ADDENDUM

Project: **Crestwood School District
Crestwood High School
Field Building & Site Improvements**

Date: **March 29, 2023**

Addendum Number: **#3**

B3 Building B: Exterior Wall Section
 Scale: 1"=1'-0"

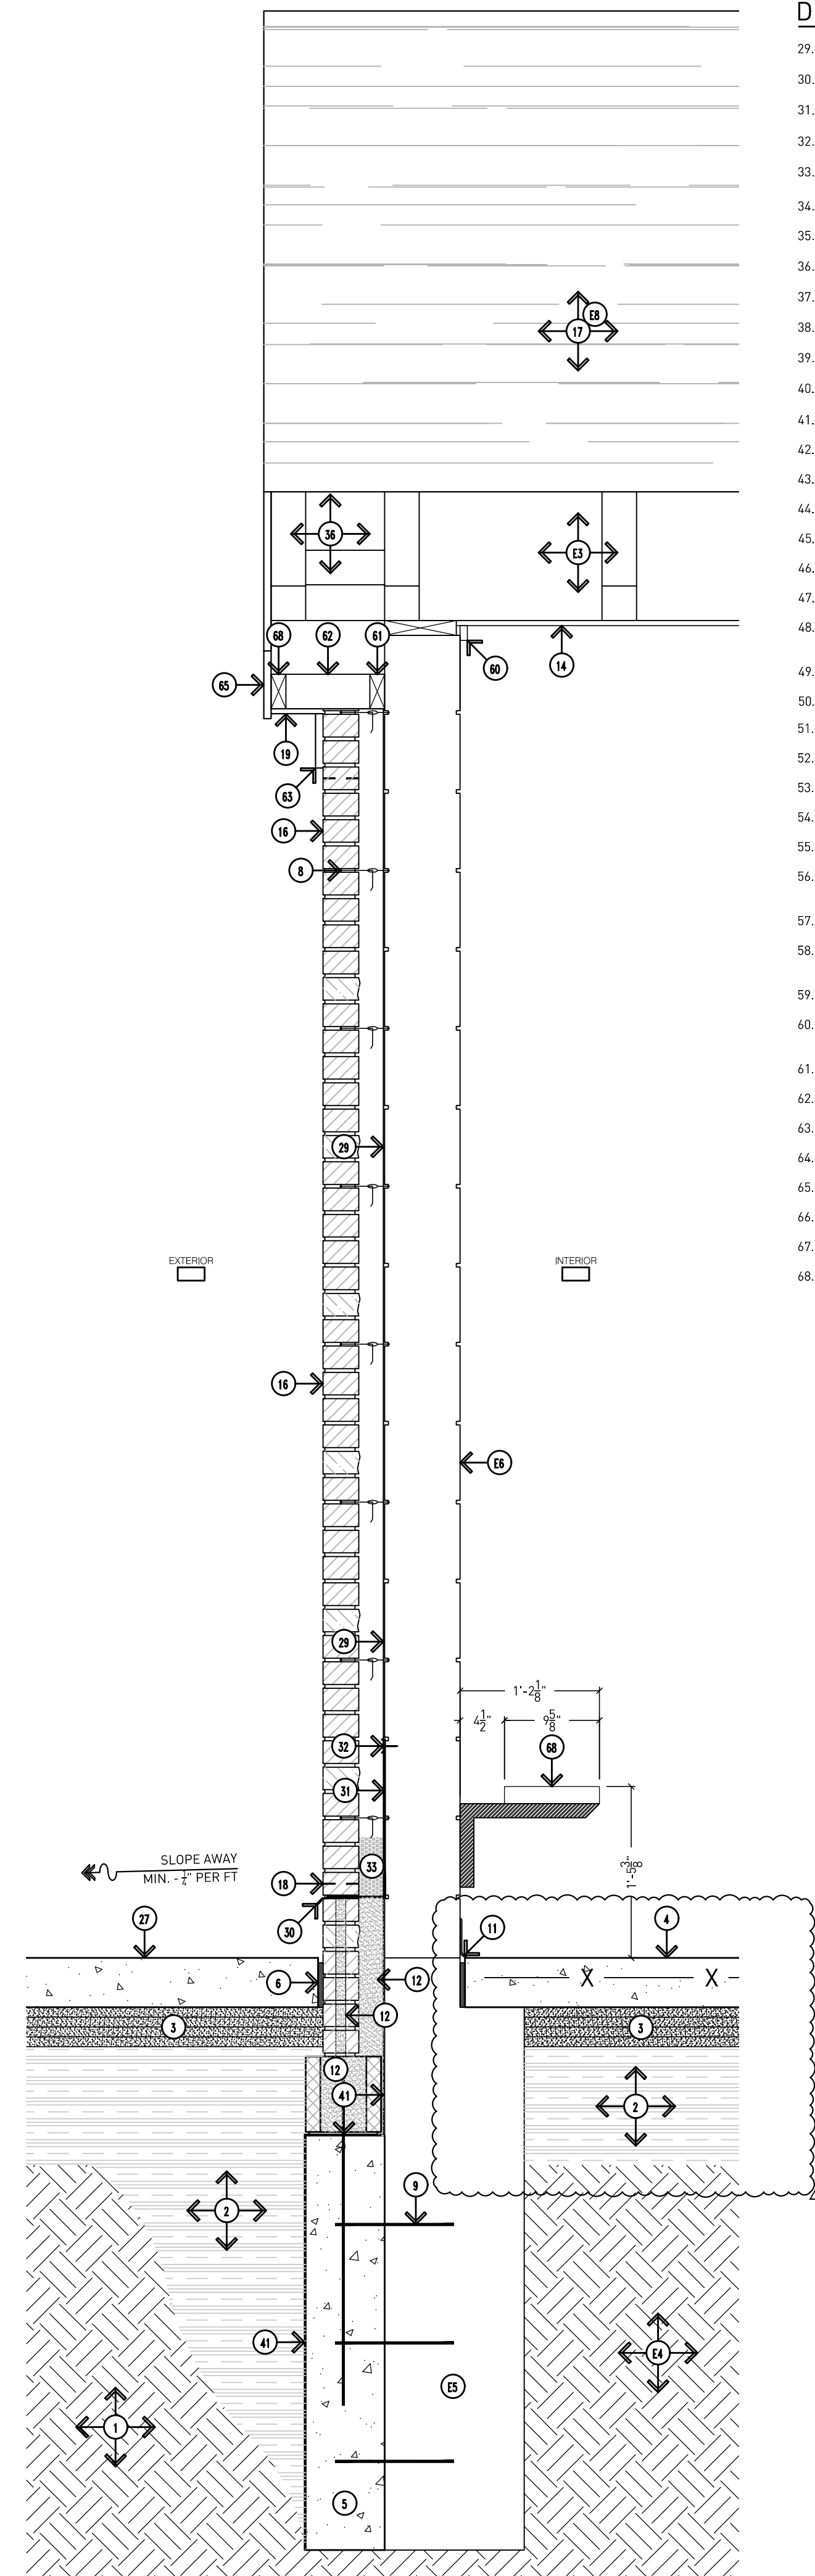
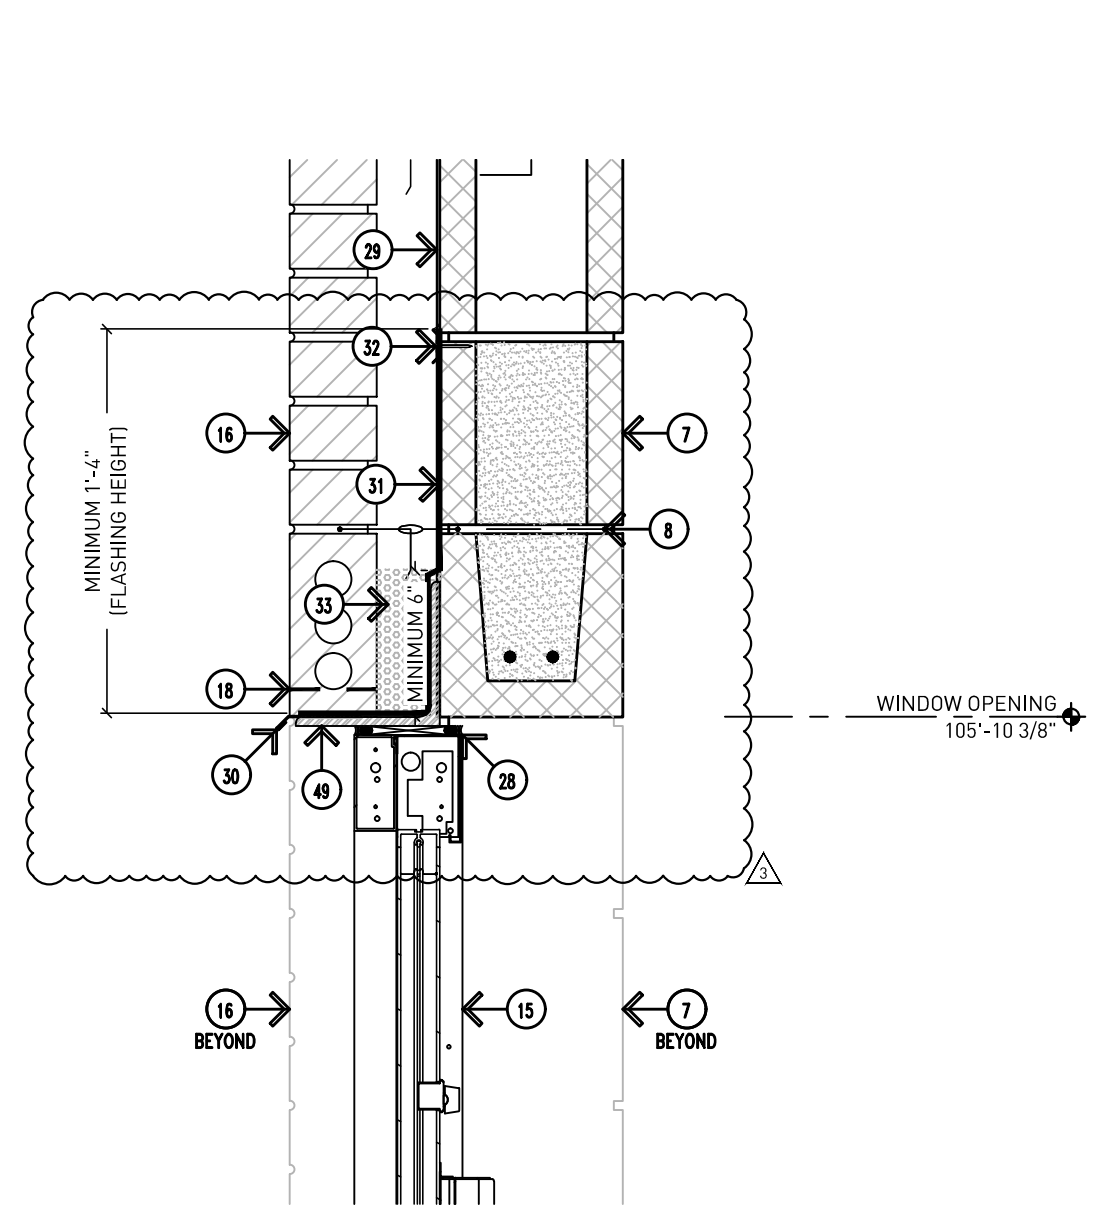
CHANGE: Note Tag E1 to 4 on detail B3/A9.03

REVISE: Detail B3/A9.03 as indicated on sheet.

REVISE: Detail B4/A9.03 as indicated on sheet.

REMOVE: Note Tag 35 from Detail B3/A9.03.

A1 Building A: Area 2 Interior Wall Section
A9.50 Scale: 1"=1'-0"

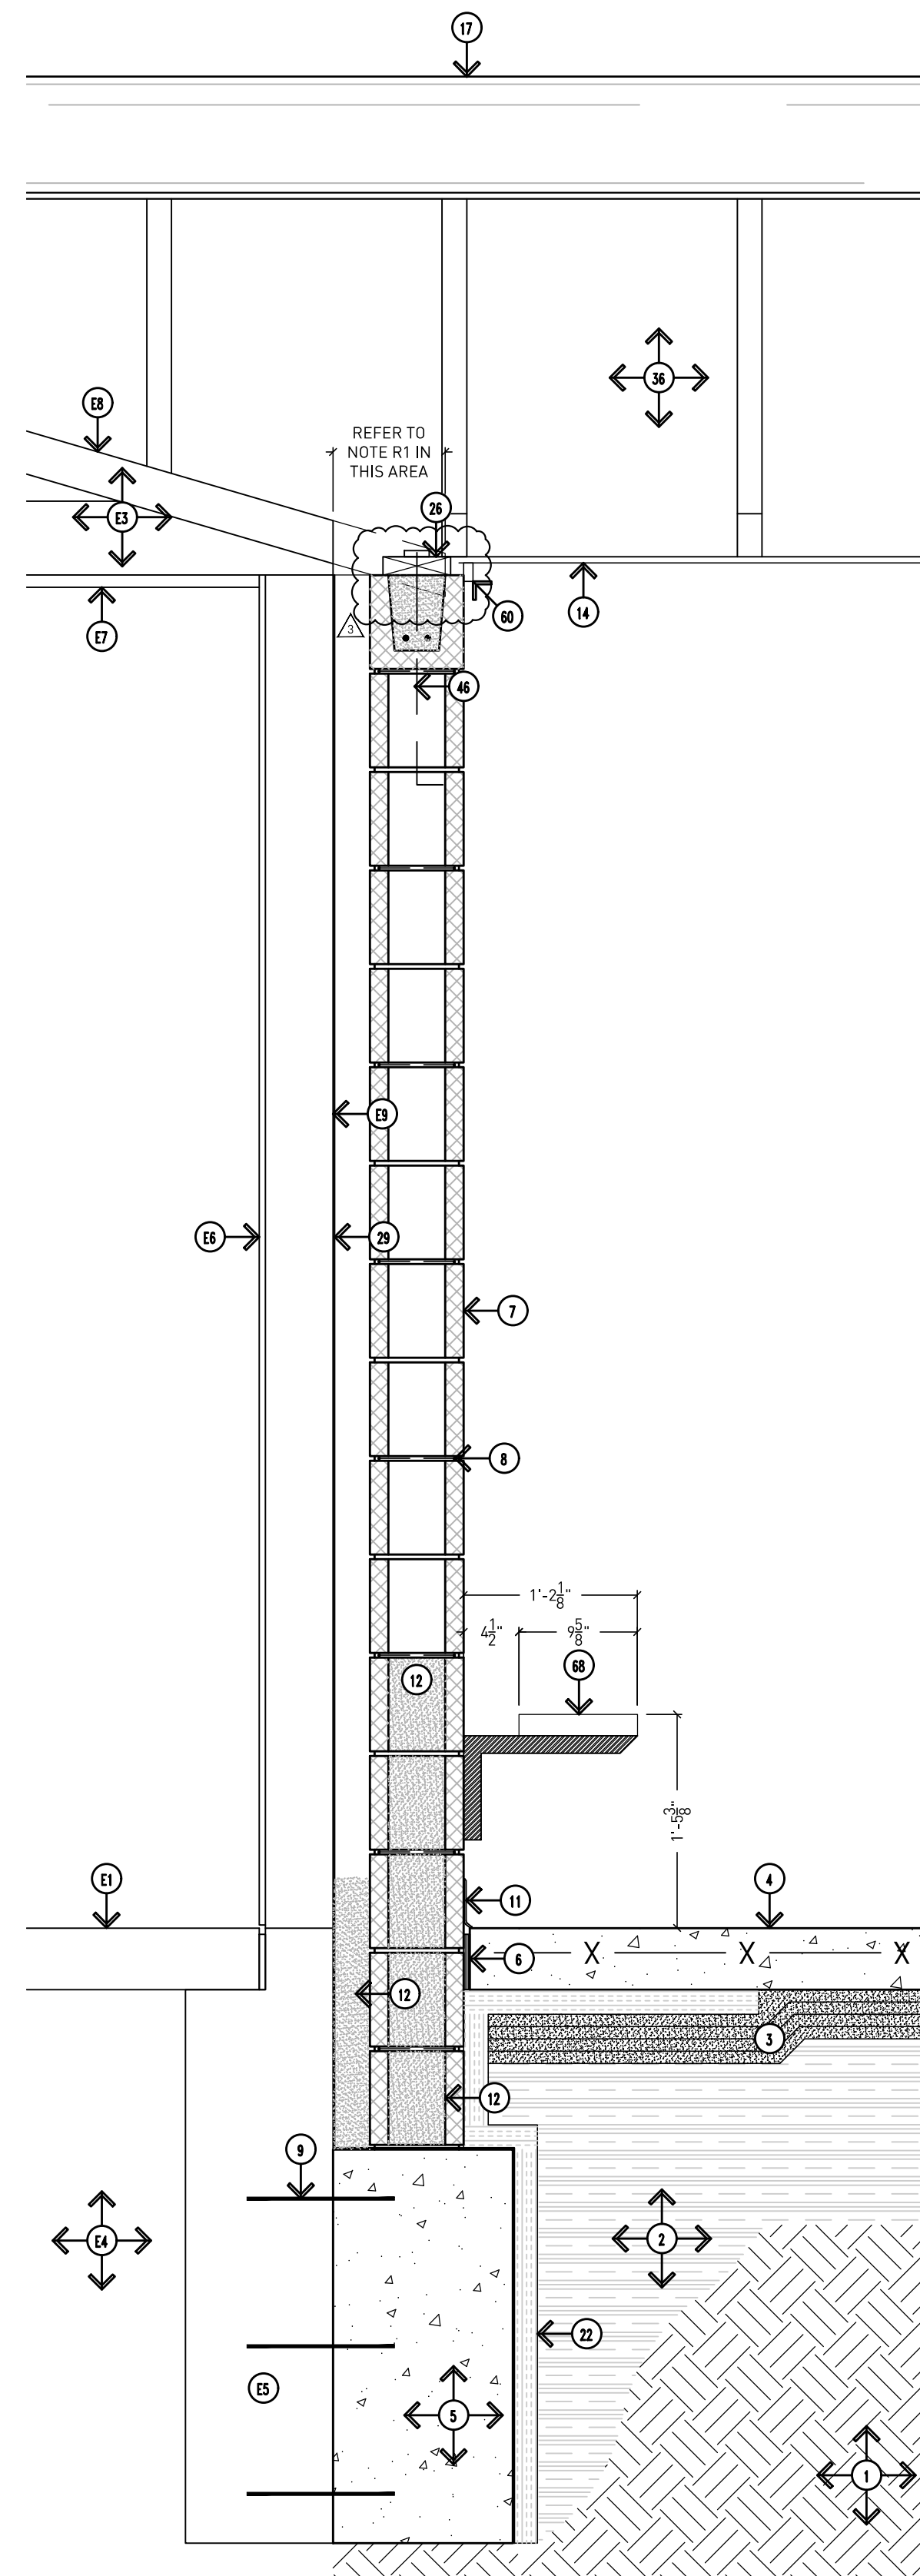
- CHANGE:** Note 21
FROM: 2" CRC main runner attached to building structure with galvanized tie wire (space per manufacturer's recommendations).
TO: Soffit framing - preservative treated 2x @ 24" O.C.
- CHANGE:** Note 26
FROM: 2"x 8" preservative treated wood plate.
TO: 2"x 6" preservative treated wood plate
- REVISE:** Detail A1/A9.50 as indicated on sheet.
